Northcrest Flex Space PPR PCD No. PPR-21-036

Re: **Northcrest Business Center: Traffic Memorandum
El Paso County, CO**

**DEVIATION REQUEST
AND DECISION FORM**

1 DEVELOPMENT SITE PLAN
DP.02 SCALE: 1" = 20'-0"

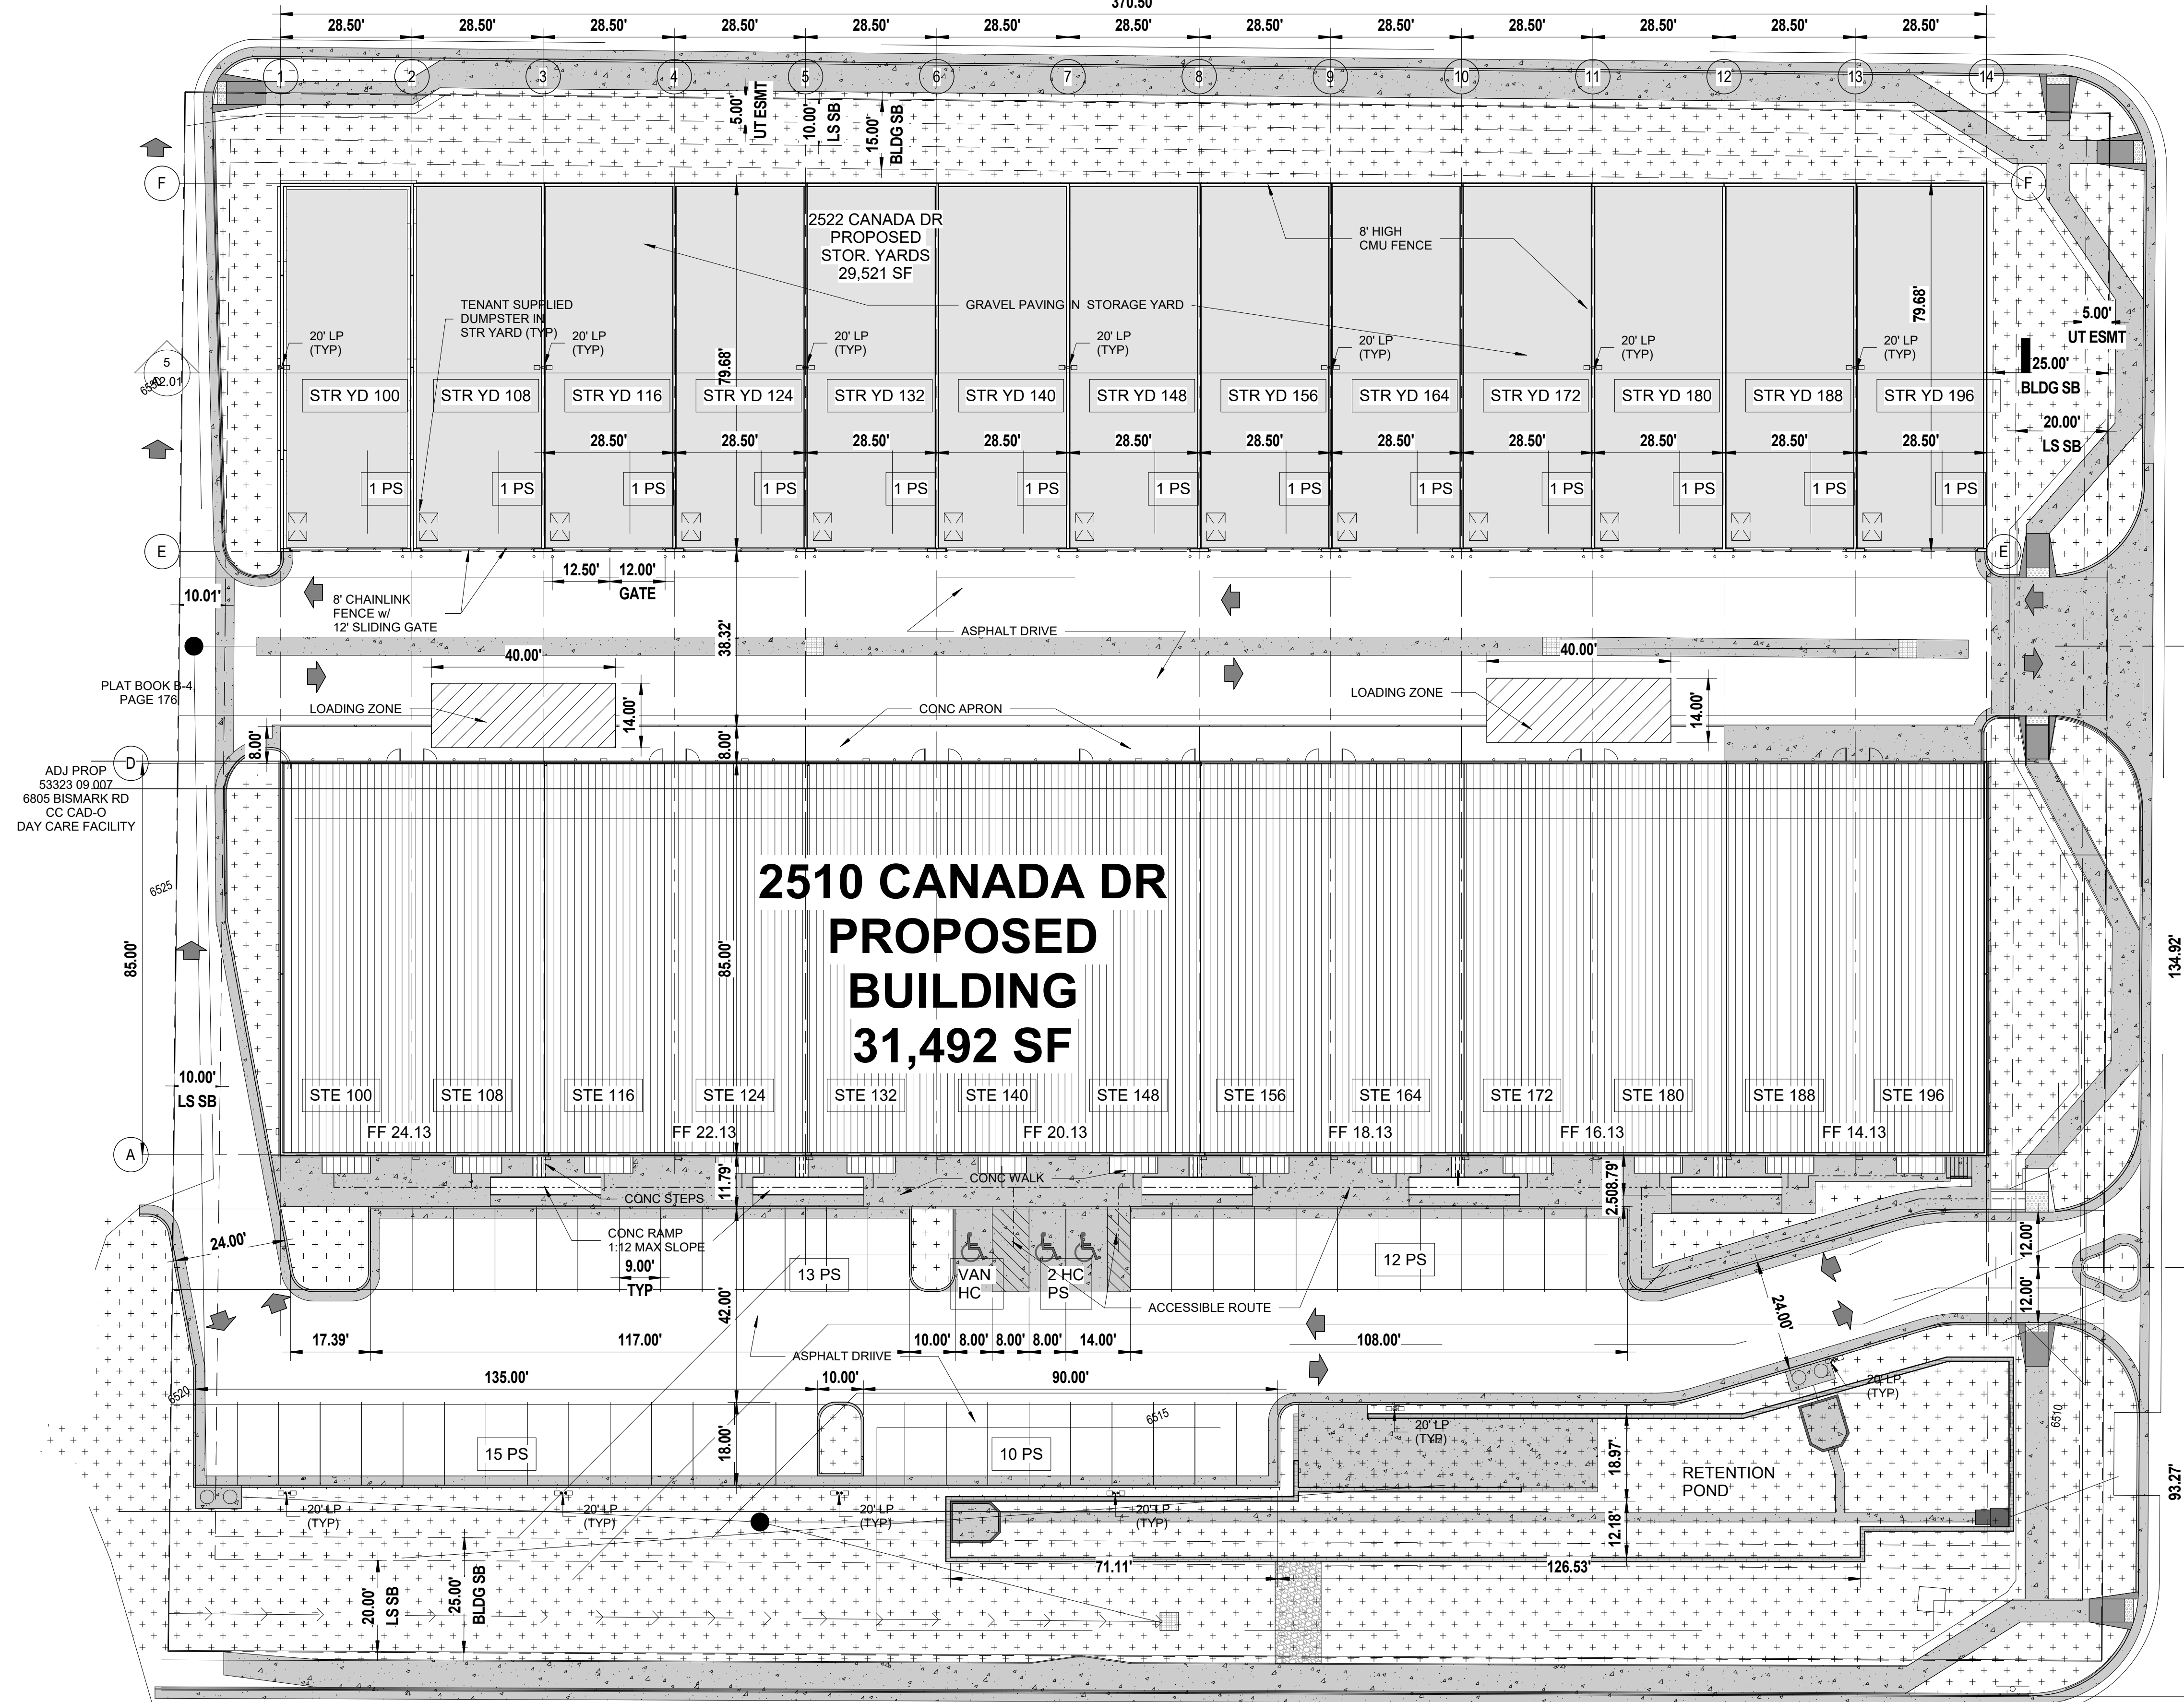
A deviation from the above is being requested for the southern and northern proposed accesses located along Canada Drive. The total site frontage along this roadway is less than 450'. It is necessary to the on site and neighboring property uses to maintain two accesses along the frontage. The two accesses have been designed to separate passenger vehicle and large truck traffic to facilitate safety. Passenger vehicles will primarily use the access to the south while larger single unit trucks would use the access to the north. Additionally, an easement is provided to the west of the site that shares access with a day care use. It is the intent of this design to minimize the necessity of any and all traffic in the proximity of the day care use.

Southern Access: The southern access, which is intended for passenger vehicles and the pedestrian accesses to the building, is proposed to be right-in/right-out along Canada Drive and connecting to the existing shared access off of Bismark Road to the west. The southern access is intended to only be used by passenger vehicles and pickup trucks. According to Section 2.4.1B Table 2-35 the Entering Sight Distance for Driveways for a 25 mph road and a single unit truck is 325'. A measure of sight distance for this entrance shows approximately 140' to Constitution Avenue. This represents a reduction from the standard of 185'. As the entrance is proposed right-in/right-out no conflicts exist with traffic coming from Constitution Avenue so no safety concerns are anticipated.

Northern Access: The northern access, which is intended for the loading traffic, is proposed as full movement along Canada Drive and connecting to the shared access off of Bismark Road to the west. The northern access is intended to be used by pickup trucks and single unit trucks. It is not anticipated that any multi unit trucks would use this access. As such and according to Section 2.4.1B Table 2-35 the Entering Sight Distance for Driveways for a 25 mph road and a passenger car vehicle is 325'. A measure of sight distance for this entrance shows approximately 255' to Constitution Avenue. As measured from Centerline to Centerline approximately 140' spacing between the southern and northern access is proposed.

Approved with the following conditions:
Southern access entrance along Canada Drive to be right in/right out only and have a sign(s) posted according to MUCTD limiting turns and vehicle size.
